Groundwater Remedy Phase 2 Construction, PG&E Topock Compressor Station, Needles, California

PG&E TOPOCK GROUNDWATER REMEDIATION PROJECT

Work Variance Request #17 – Relocate Phase 2 Remedy Produced Water Conditioning Facilities to Transwestern Bench

Variance Request No.: 17

TOPOCK GROUNDWATER REMEDIATION PROJECT
**TRANSWESTERN BENCH
SITE DEMOLITION PLAN**
GAS TRANSMISSION & DISTRIBUTION
PACIFIC GAS AND ELECTRIC COMPANY
SAN FRANCISCO, CALIFORNIA

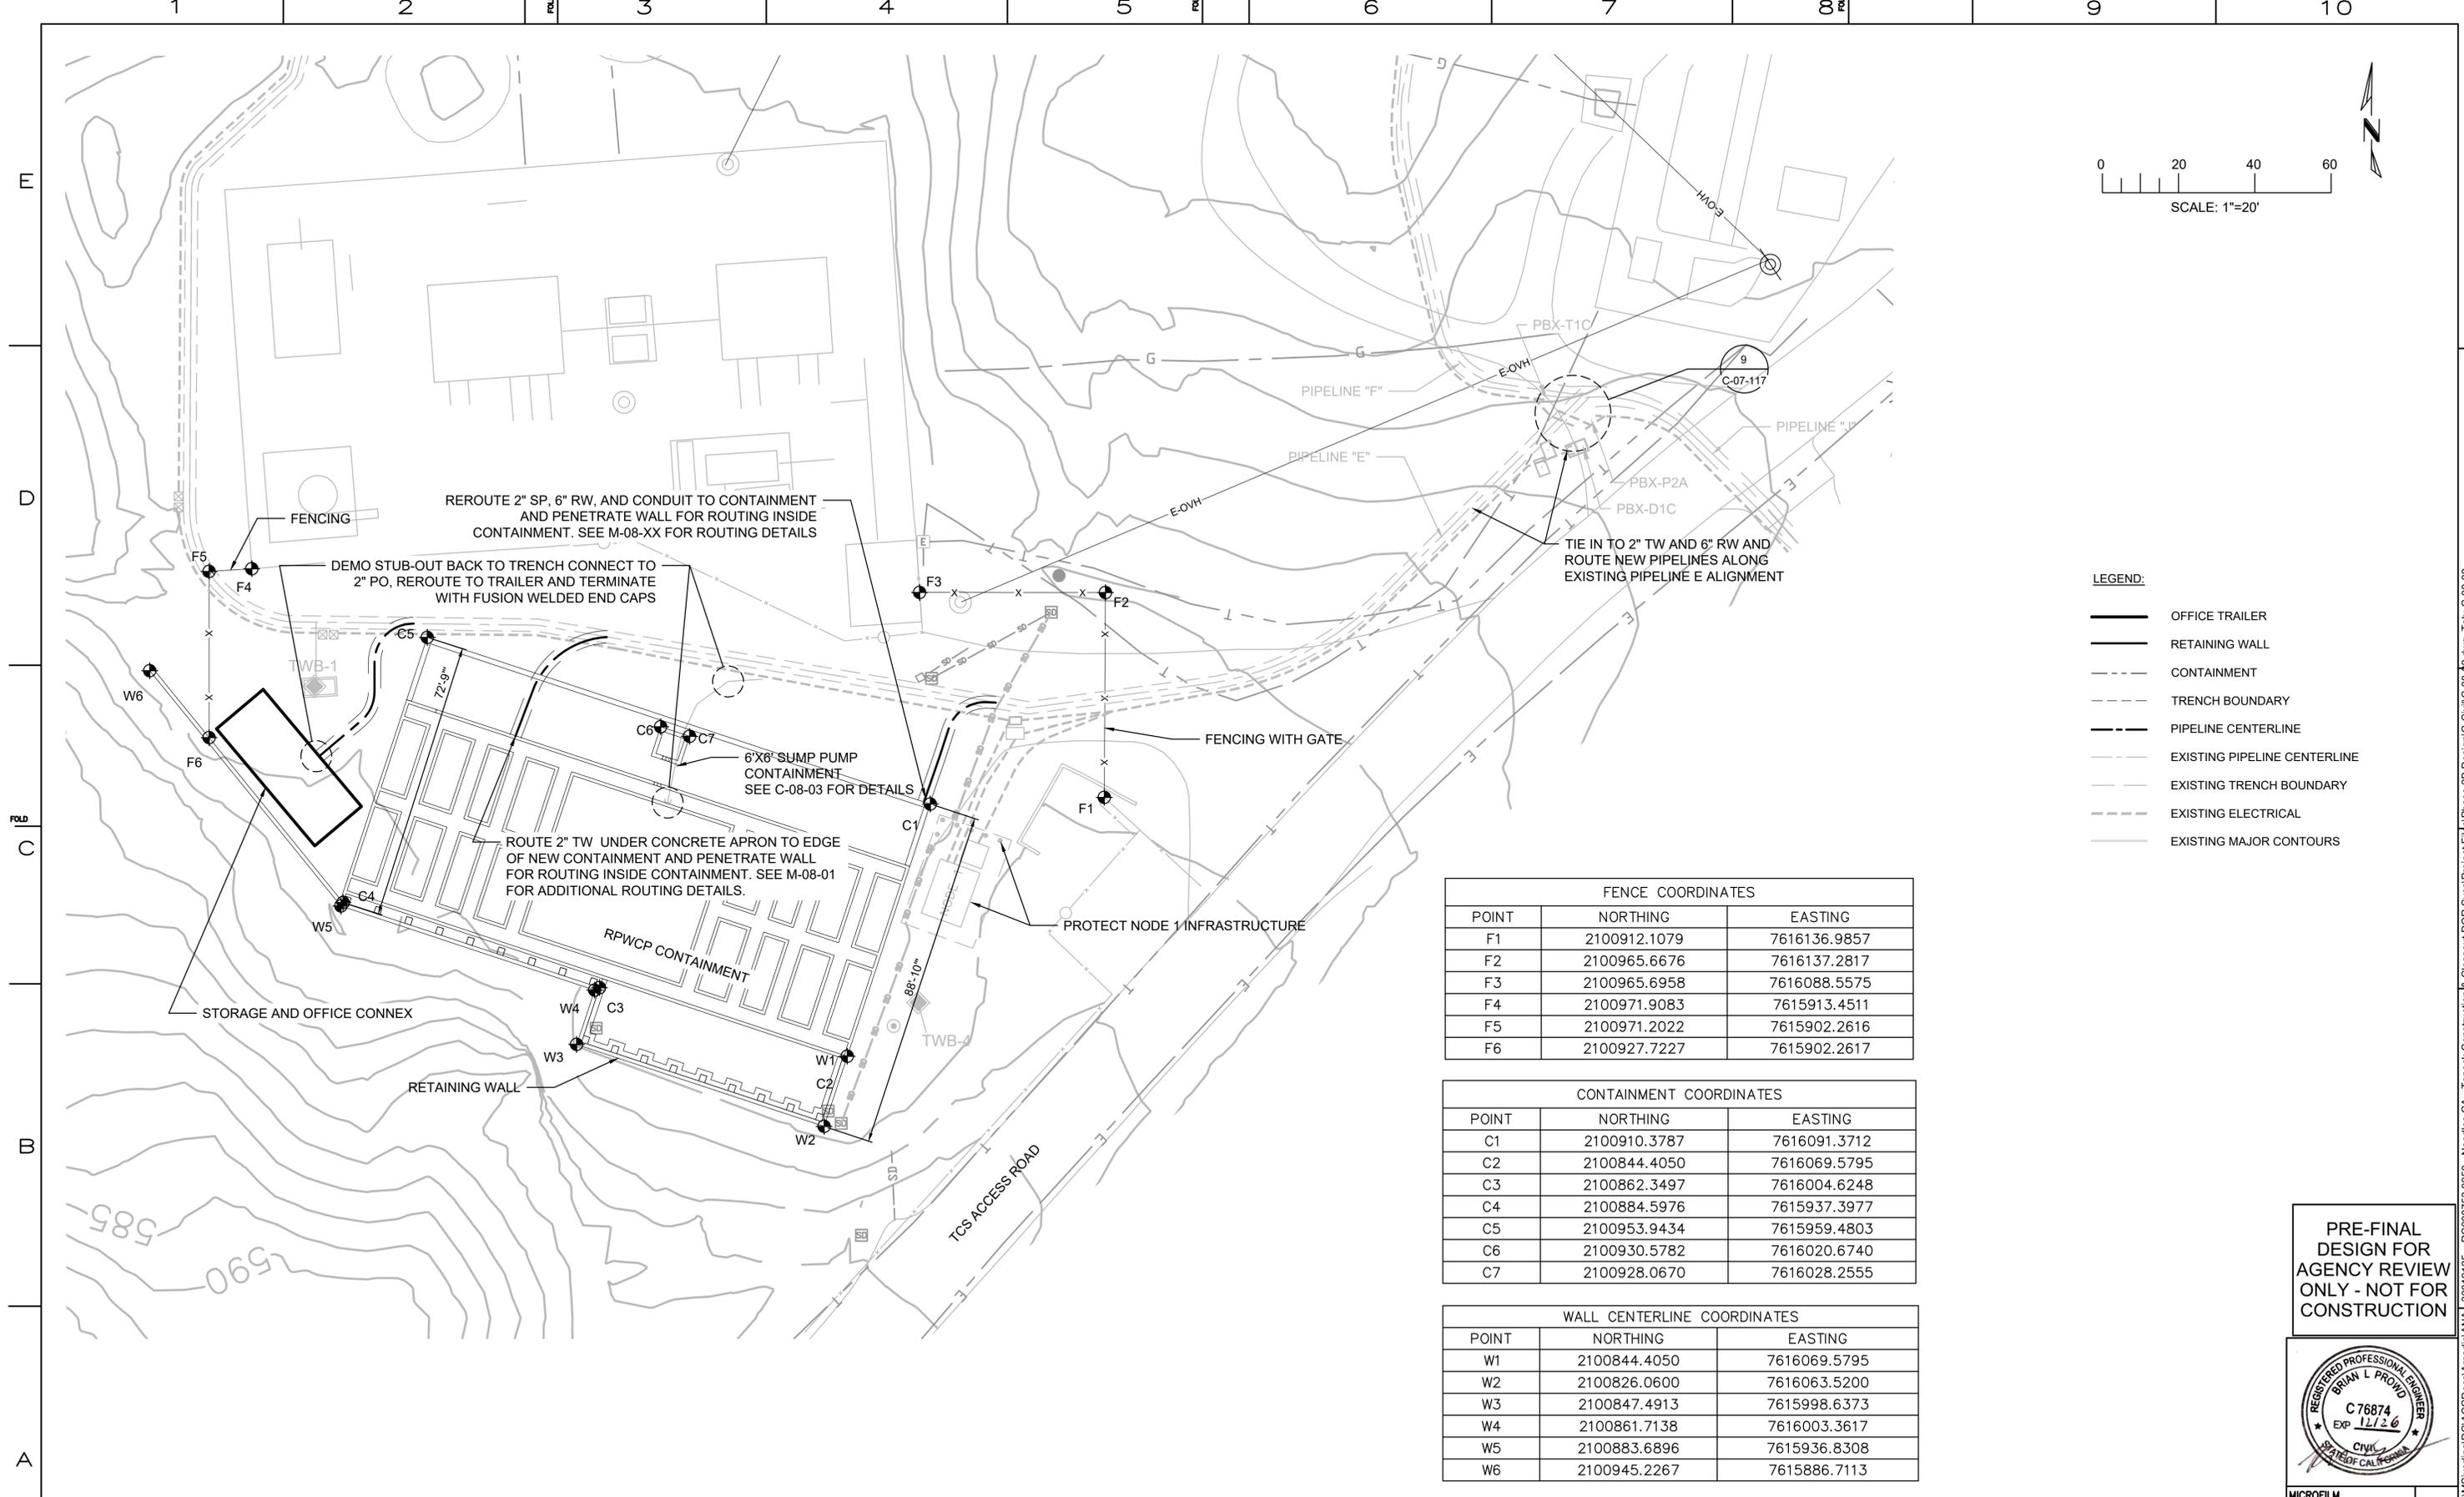
To accommodate the RPWC system at the TWB, PG&E proposes to demolish various existing features at the TWB including the decon pad, concrete pad, barrier wall, stormwater features, and piping/conduits (see Drawing C-08-01, Transwestern Bench Site Demolition Plan). A new retaining wall and a new secondary containment pad will be built at the TWB. To retain the functionality of a decon pad at the TWB, a new concrete apron (approx. dimension of 138 ft long by 15 ft wide) will be built adjoining the north side of the new secondary containment (see Drawing S-08-03).
